London, 7th January 2021

I am getting in touch with you again today to strongly reiterate my objection to the revised drawings submitted on the 13th_November_2020 for the Planning Application Number 2020/2839/P.

PROPOSAL SUBMITTED 13.11.2020 – ENCROACHES ON 39 AS THE ENTRANCE IS NO LONGER SET BACK FROM THE FRONT OF THE BUILDING

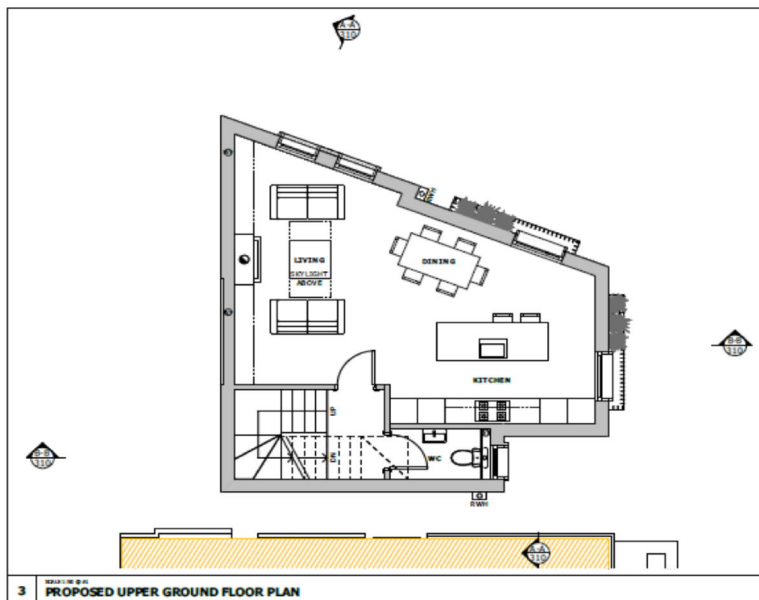
Going back to the revised plans I can't help noticing that they now bring forward the front line of the building at full height as you can see from the

This causes the planned building to be effectively much closer to n. 39 and it creates a narrow passage between the two buildings, not to mention the diminished amount of light. It also makes the whole site appearing, even more, as an unpleasant and bulky concrete structure, in total disagreement with the Conservation Area rules.

ORIGINAL PROPOSAL – ENTRANCE IS SET BACK AND THERE IS ONLY ONE WINDOW TO THE FRONT OF THE BUILDING

LOCATION OF MANHOLE

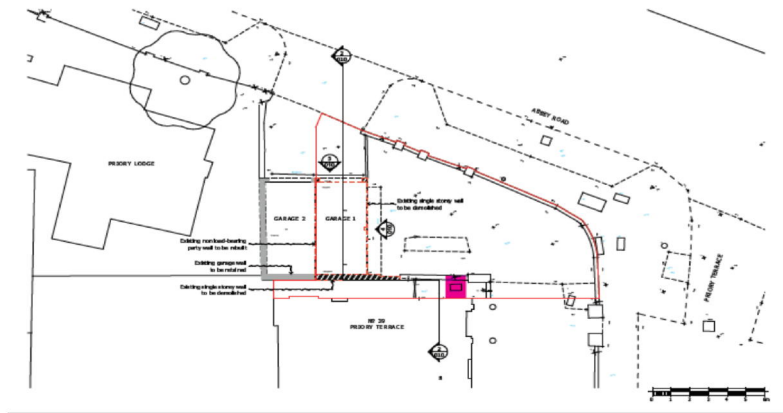
Also, I have highlighted in **purple** below the location of the manhole in the narrow passage between the buildings – there surely are drains running to that manhole and from it to the general area sewage.

CONTIGUOUS PILED WALL AND CAPPING BEAM WILL INTERFERE WITH THE EXISTING DRAINS AND MANHOLE

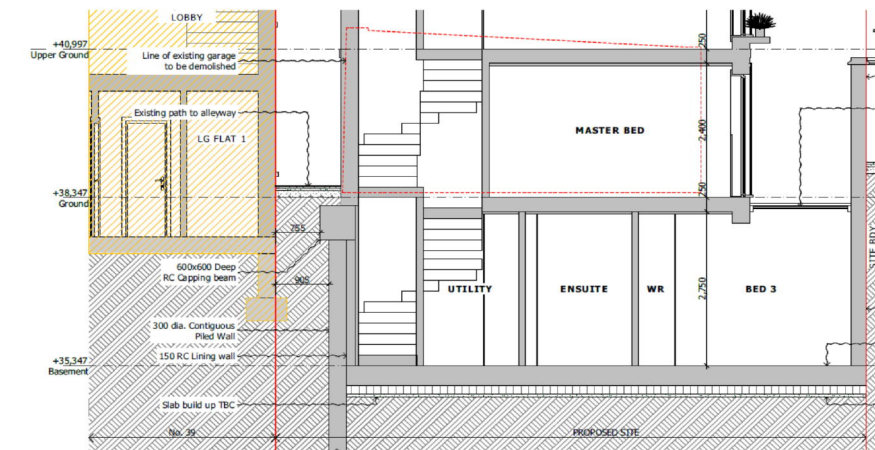
Please note the copy of the section from the revised plans showing the width of the pathway and the extent of the piles and beams. This plan would therefore inevitably interfere with the current drainage of both the waste and rain waters.

Revised Ground Floor Plan proposed showing tree (green) and Cellular Attenuation Tank (blue)

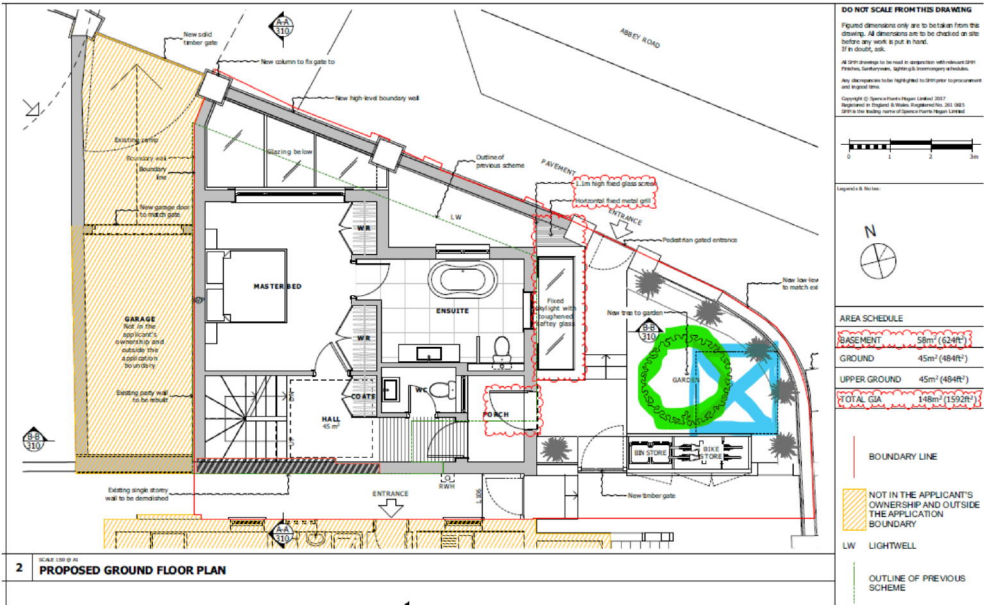
According to the [SuDS Maintenance Guide](#) a below-ground water storage system (please see the drawing below - highlighted in blue) requires regular monthly maintenance and inspection.

How can it be guaranteed that any future owners will ensure that this is carried out? or that he/she will employ and bear the costs of a maintenance organisation? We know this is impossible to guarantee. In which case, there can be the possibility of contamination or water stagnation, and the related consequences.

Moreover, the revised plans show a tree (in **green** in the drawing below) to be planted above the 2m x 2m storage tank and the roots can easily interfere and damage the tank ahead of time.
